WHITE MOUNTAIN PRECAST, LLC
173 BUXTON INDUSTRIAL DRIVE, PO BOX 870
HENNIKER, NH 03242
PHONE: 603-428-3218
FAX: 603-428-7428

25' Span x 6'-6" Rise Rigid Frame Bridge
Rte 100 Bridge Replacement
Ludlow, VT

DWG NO.
S1.0

RECEIVED
OK'D BY [Signature] OK'D BY [Signature]
MAY 01 2009
RESUBMIT APPROVED [Signature]
BY CPW DATE 5/2/09

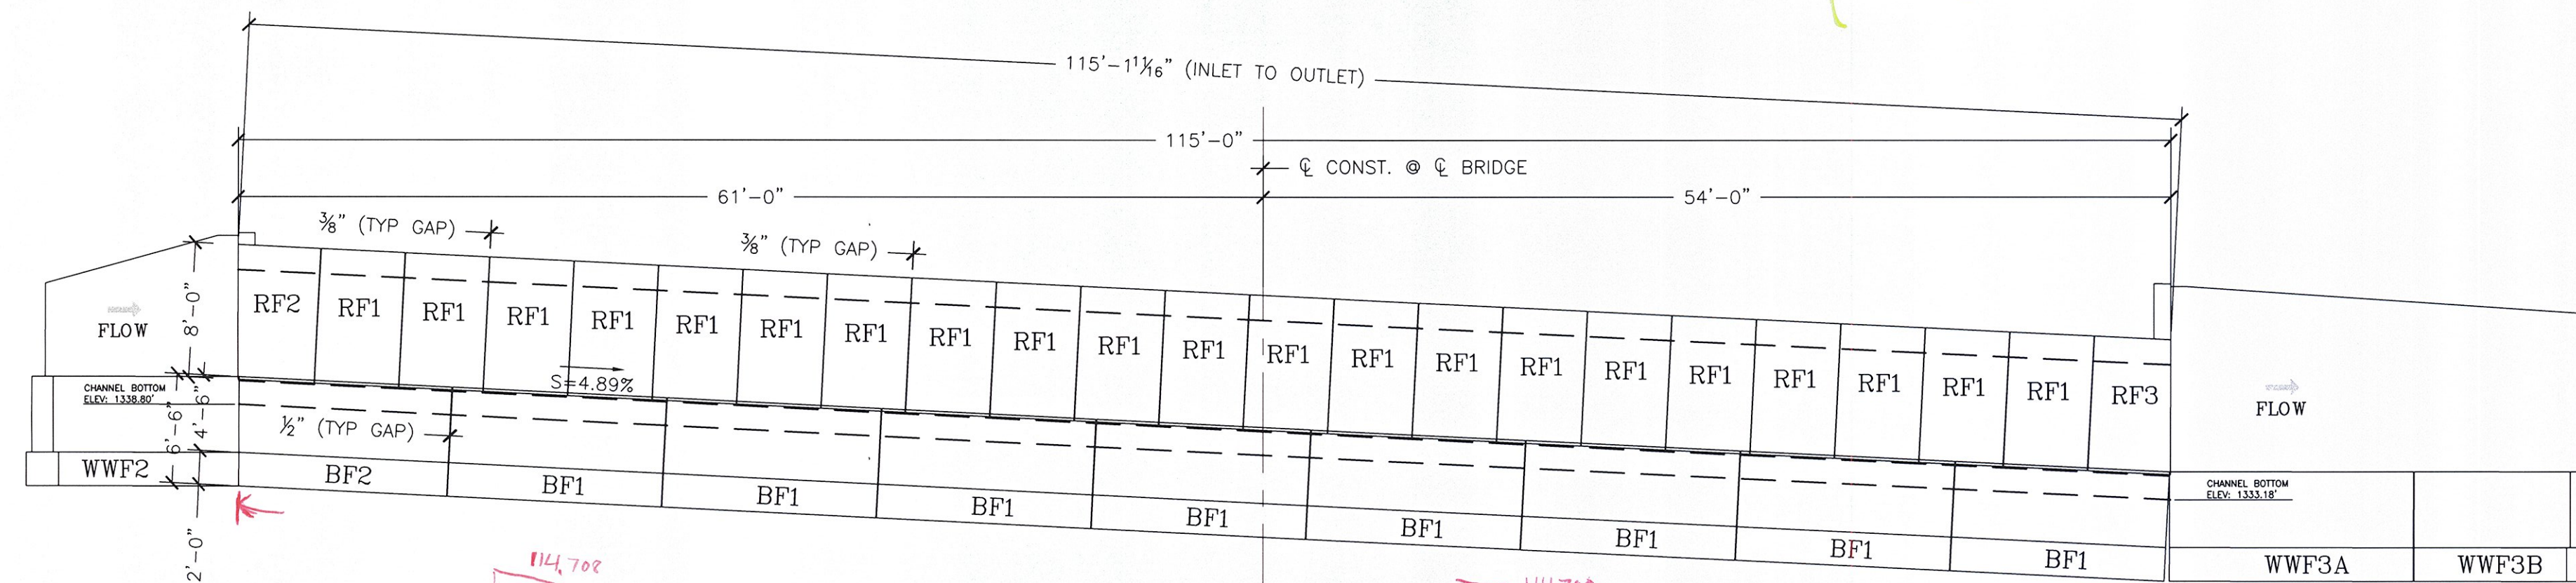
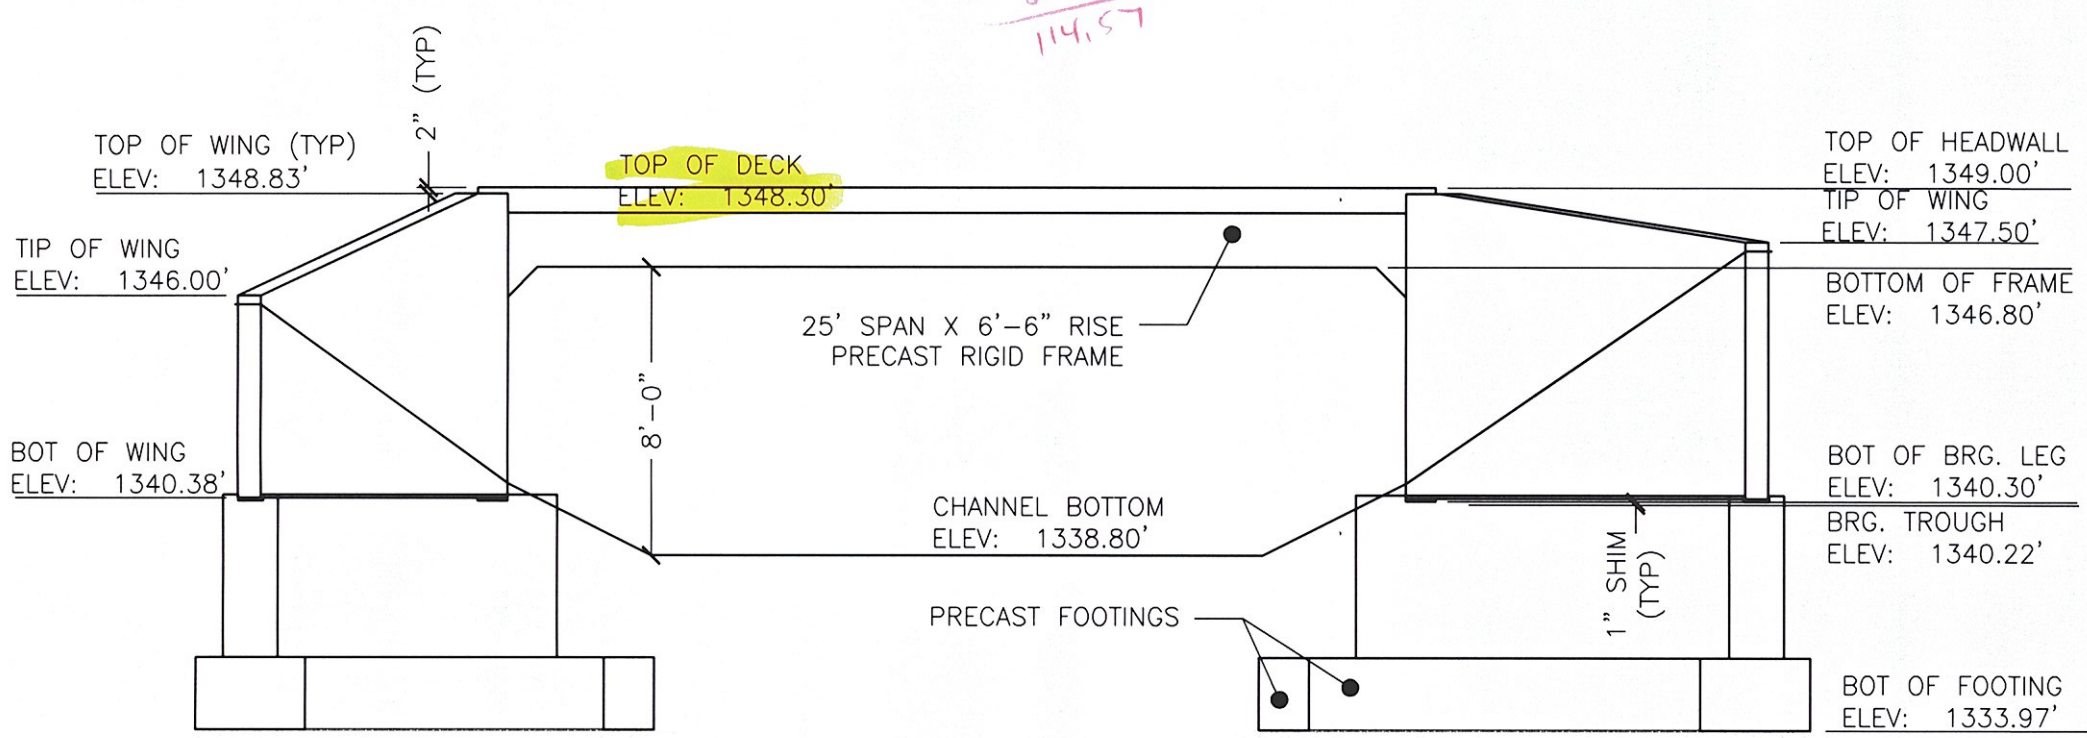
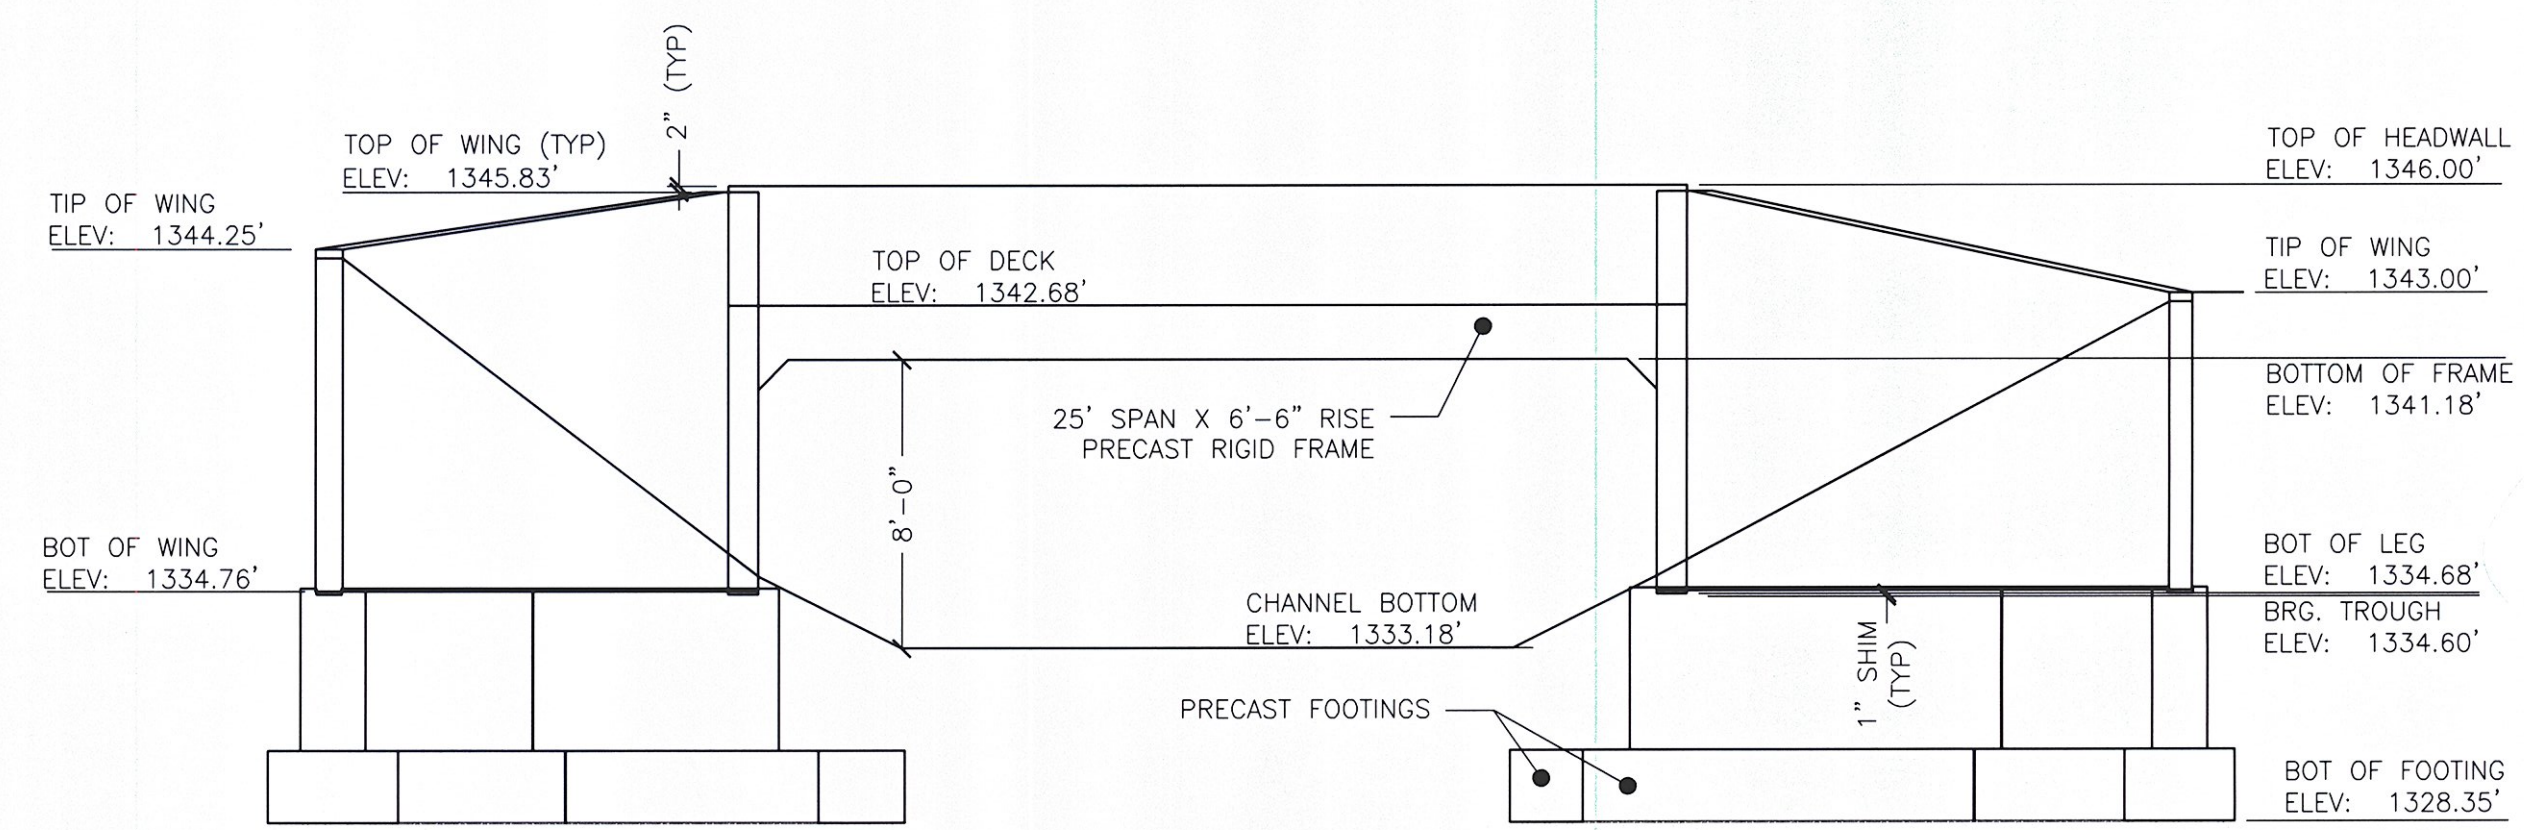
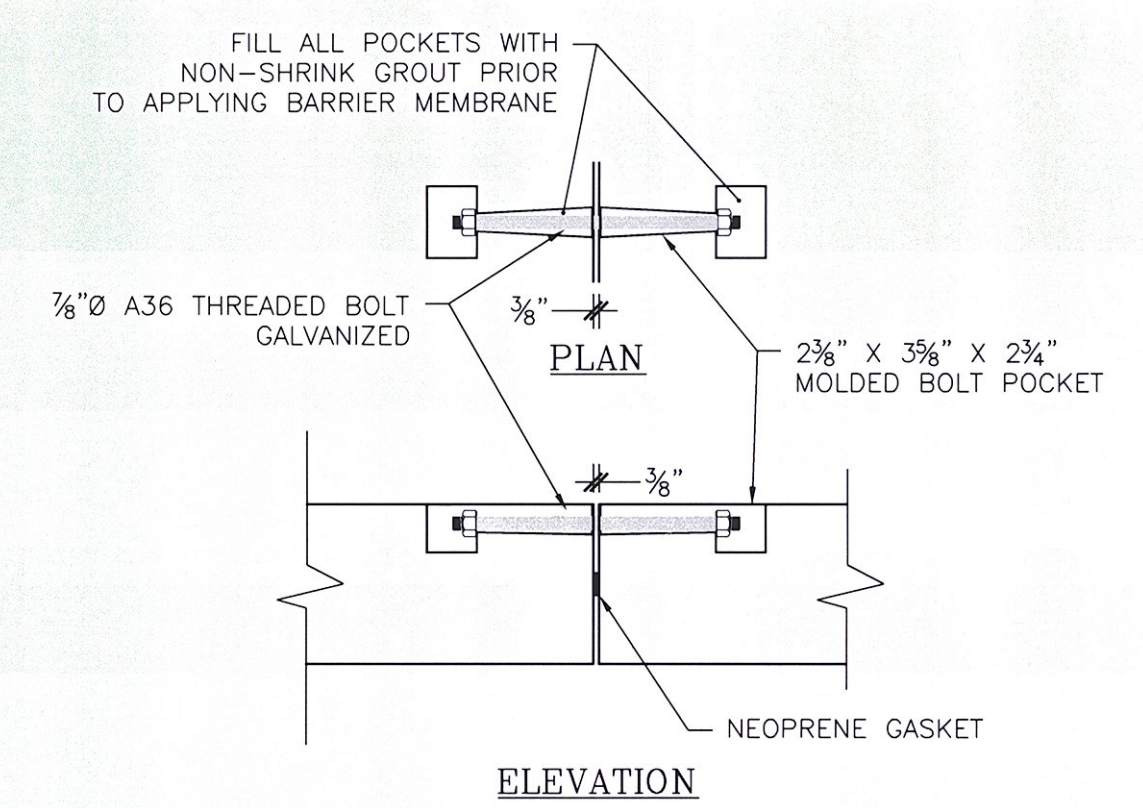
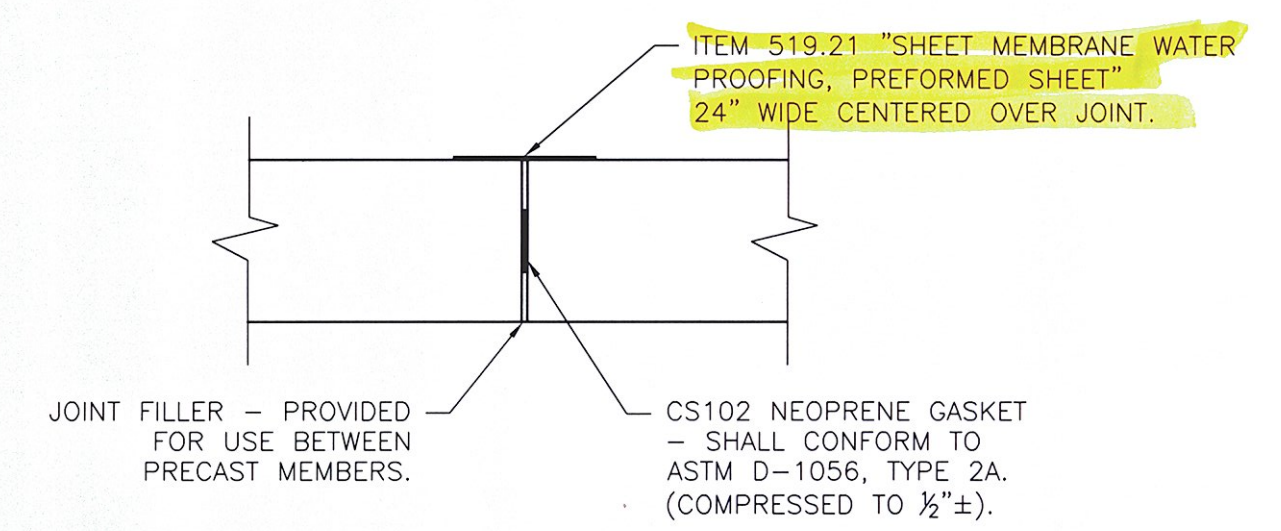
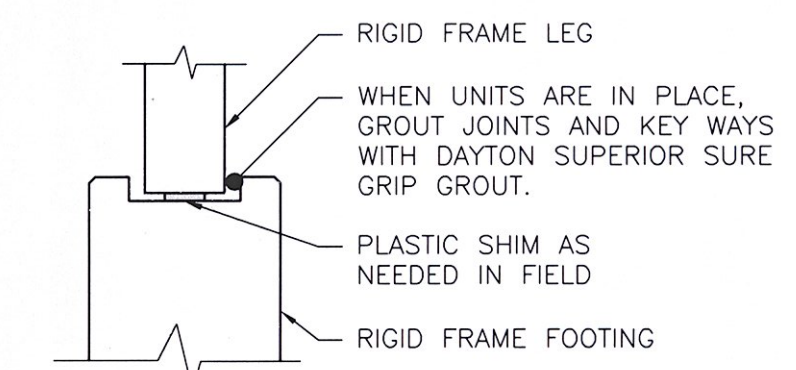
Tranah changed from 2" to 3"
Flow as noted
No bar 1/2"
